# DART SERVICE INSTRUCTION

TO AMEND INSTALLATION INSTRUCTIONS IIN-D135-1027 REV. E AND  
INSTRUCTIONS FOR CONTINUED AIRWORTHINESS ICA-D135-1027 REV. 2 OR LATER APPROVED REVISIONS  
REF. TCCA STC: SH18-49  
REF. FAA STC: SR04276NY  
REF. EASA STC: 10068097  
REF. DGAC MEXICO STC: IA-633/2019

## 1.0 PURPOSE

The purpose of this Dart Service Instruction (DSI) is to provide instructions to allow customers to install AS22-38-11B and AS22-38-12C Cargo Hook Attachment Fittings (or equivalent) onto D135-1027-101/-103/-201/-203 Crosstubes Installations @ CHG 001. The required provisions are pre-drilled on CHG 002 or later crosstubes.

**FIGURE 1: D135-1027-241/-243 AFT CROSSTUBE**  
(VIEW LOOKING AFT)

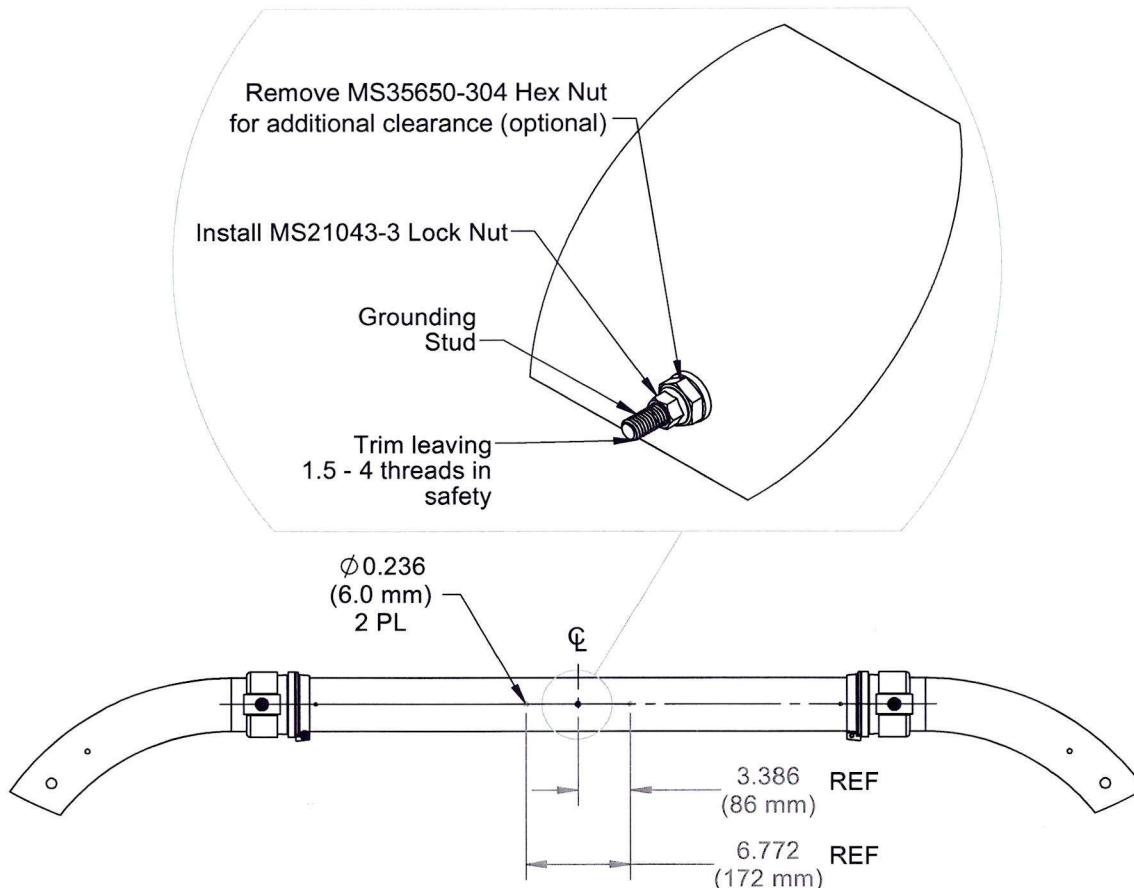
- 2.1 If required, remove the landing gear from the aircraft per Chapter 32.1 of ICA-D135-1027.
- 2.2 On the D135-1027-241/-243 Aft Crosstube, install MS21043-3 Lock Nut and trim the forward side of the central grounding stud leaving 1.5 - 4 threads in safety as shown in Figure 1 of this Service Instruction. If required for clearance, it is permissible to remove the MS35650-304 Hex Nut and replace with the MS21043-3 Lock Nut only to allow additional trimming. Tighten MS21043-3 until snug.

- Note:** It is no longer permissible to use the fwd-center grounding stud of the D135-1027-241/-243 Aft crosstube for grounding.
- 2.3 Drill 2x  $\varnothing$  0.236"-0.244" ( $\varnothing$  6.0-6.2 mm) holes on the fwd side of the D135-1027-241/-243 Aft Crosstube as shown in Figure 1 of this Service instruction. The holes are symmetrical about the center of the Aft Crosstube and 6.752" - 6.791" (171.5 - 172.5mm) apart. It is recommended to transfer mark holes from OEM aft cargo hook attachment cross-bracket to ensure correct fit.

- 2.4 Drill 1x  $\varnothing$  0.236"-0.244" ( $\varnothing$  6.0-6.2 mm) hole in the middle of the aft side of the D135-1027-141/-143 Fwd Crosstube as shown in Figure 2 of this service instruction.
